ADDENDUM NUMBER THREE (3)**CATAWBA COUNTY****BLACKBURN RESOURCE RECOVERY FACILITY OPERATOR'S BUILDING****PROJECT NO. 26.00701**

This Addendum Number 3 (Three) is issued this the 28th day of October 2026, to all parties who hold a set of Bid Documents for the project entitled: “**BLACKBURN RESOURCE RECOVERY FACILITY OPERATOR'S BUILDING**”. This Addendum Number 3 (Three) shall become part of the Contract Documents and its receipt acknowledged on the bid documents at the time of bidding.

SHEET TITLE
TYPICAL LIGHT GAUGE FRAMING DETAILS

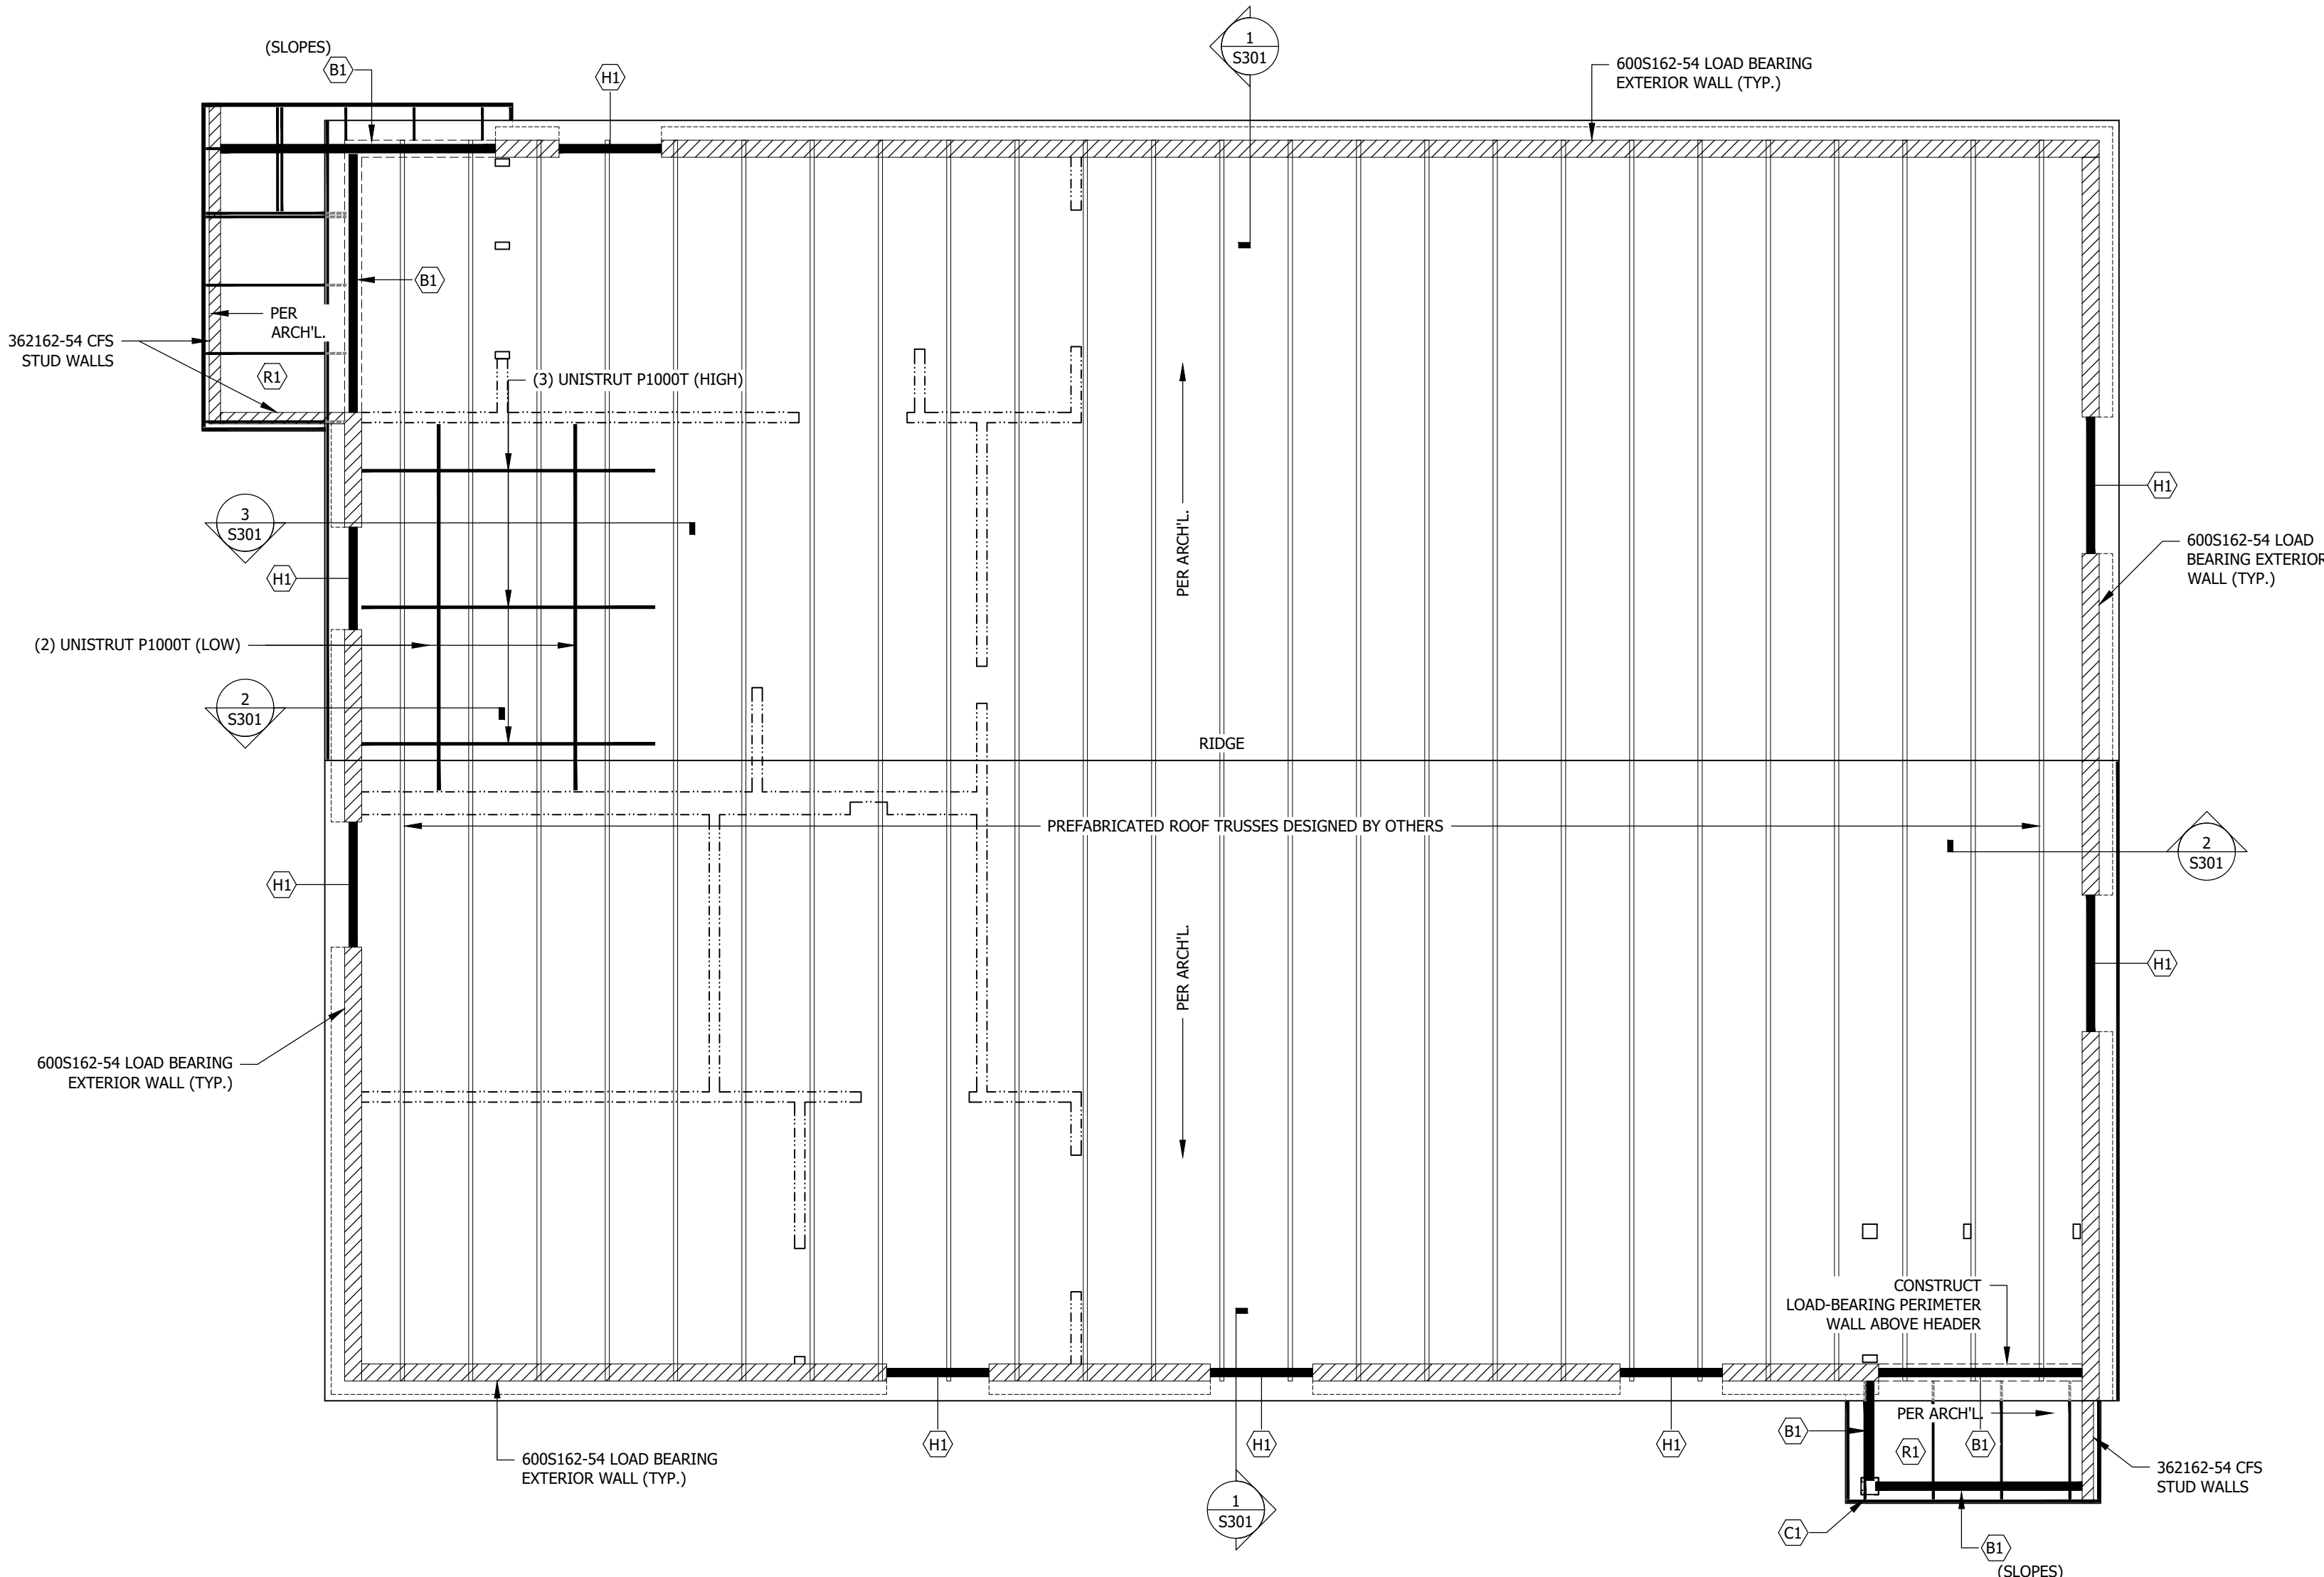
36. Stud-to-track and jamb connection requirements: Please confirm that the structural framing connection details on S002 govern load-bearing CFMF construction, including stud-to-track fasteners and jamb/header configurations, and clarify whether the specification's clip-and-tie language imposes additional requirements. Confirm that

crimped connections under Section 09 22 16 apply only to non-load-bearing partitions. (Reference: S002; Specification 05 40 00, 3.02; Specification 09 22 16, 3.02)

- a. The details on Sheet S002 are intended to cover the CFS typical connections. The Engineer of Record will need to review the truss shop drawings.
37. SFIA certification and installer qualifications: Section 054400 requires SFIA-accredited contractors and fabricators, along with installer certification documentation. Please confirm whether these qualifications are mandatory for roof truss installation or whether equivalent qualifications will be accepted. (Reference: Specification 054400, 1.05(D) and 1.06)
